Project Name: Wilco
Project Address: W 11th & Willow Creek
Permit Number: 23-01679-01

RE: Structural Response to Plan Review for Wilco in Eugene, OR

DESCRIPTION: FRONT CMU WALL @ MAIN FACADE

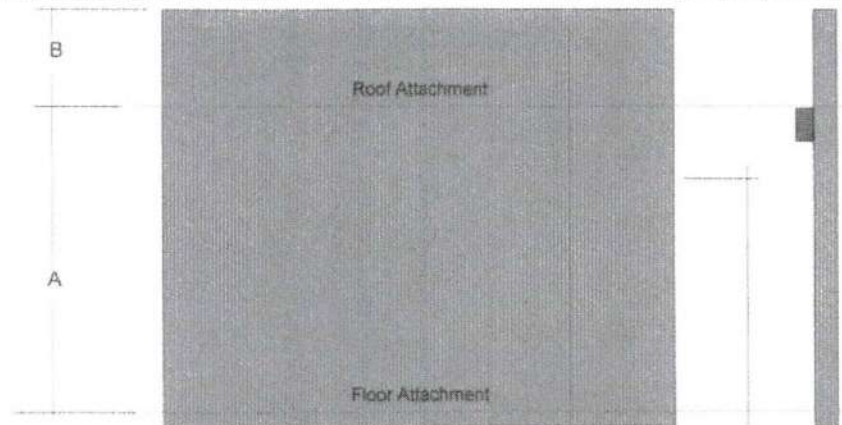
FOLLOW UP COMMENT: The response references revised calculations. It does not appear that revised calculations were submitted with the plan check response. Please submit calculations showing the derivation of lateral forces acting upon these roof structures and the complete load path for resolution of lateral forces through the building frame. It appears that the facade and loading cover both transfer lateral forces to the CMU walls at mid-height. Please show how these forces are resolved through out-of-plane bending of the walls.

- A calculation has been added to model the concentrated wind load that the main facade would apply to the CMU wall. Seismic loads from the fully grouted CMU wall control the design at this condition. See pages 25-27 of the revised Calculations.
- The loading dock cover has been revised to resist all out of plane loads at the (2) 4'-0" long side walls. New sheathing, top plate nailing, and anchor bolts have been specified. This relieves all tension loads at the glulam beam bracket. See page 58 of the revised calculations and details A and B on S3.2 of the revised plans.

Lateral check on Loading dock cover

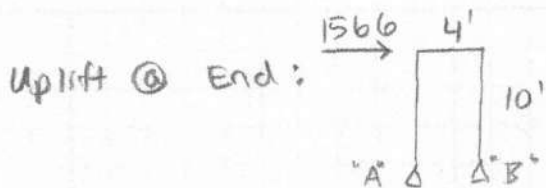
FOLLOW UP COMMENT: The hanger appears to be based on a Simpson HGUM bracket. However, the Simpson catalog does not provide a tension capacity for HGUMs. Additionally, the eccentric configuration of this bracket will result in unbalanced distribution of shear and tension to the anchors. Please provide an analysis showing the adequacy of the hanger.

- The loading dock cover has been revised to resist out of plane forces at the 4'-0" shear walls. The custom bracket is based off of the Simpson HGUM bracket that has a documented shear capacity of 7,555 lbs. The custom bracket does not change the eccentricity of the already defined Simpson bracket but does increase its shear capacity by increasing the number of Titen HD's from 8 to 12, while keeping the same anchor spacing and pattern. The required design load is 8,500 lbs. The additional (4) Titen HD's are adequate to resist the 945 lbs of additional load.

Lateral check on Corner Facade

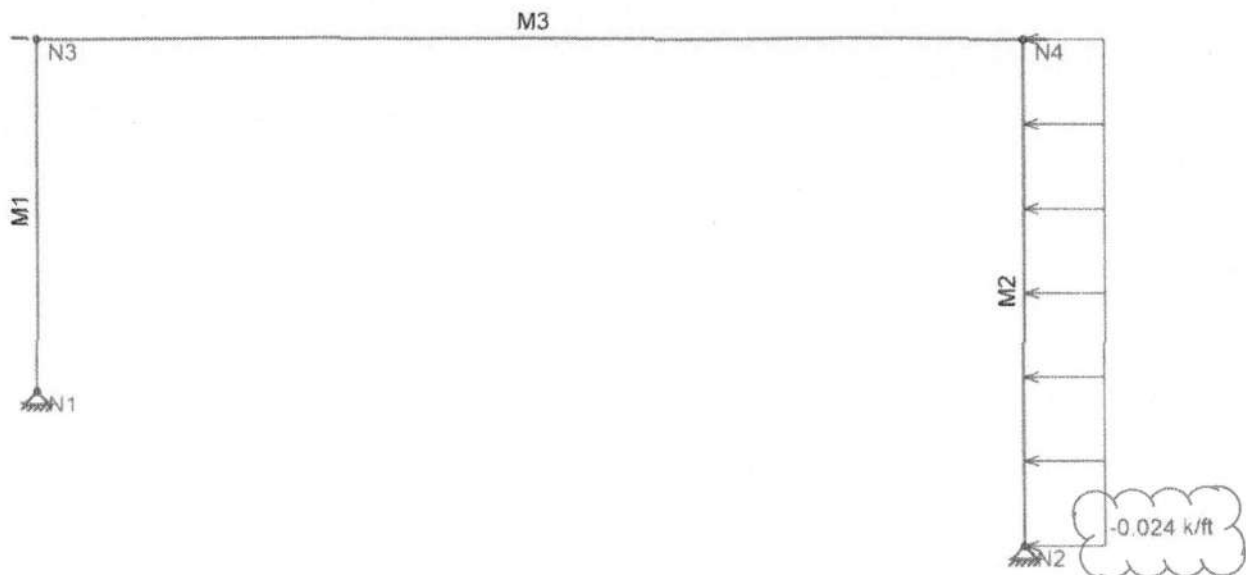
Please clarify the lateral force resisting systems for the structures shown on this sheet. Wind loads applied to portions of the entry-facade and tower-facade projecting above the main building roof should be designed as rooftop structures and subject to the wind load factors of ASCE 7 29.4.1. (OSSC 1609.1, 1613.1)

- Back Corner Facade: The CFS framed roof diaphragm is laterally tied to the CFS framed shear walls. The CFS framed shear walls are framed down to the main building cmu walls and steel reinforcement in the main roof system. The shear walls have holdowns spaced at 4'-0" o.c. to resist all uplift forces. See sheet S3.3 for details and pages 64 & 68 of the revised calculations.
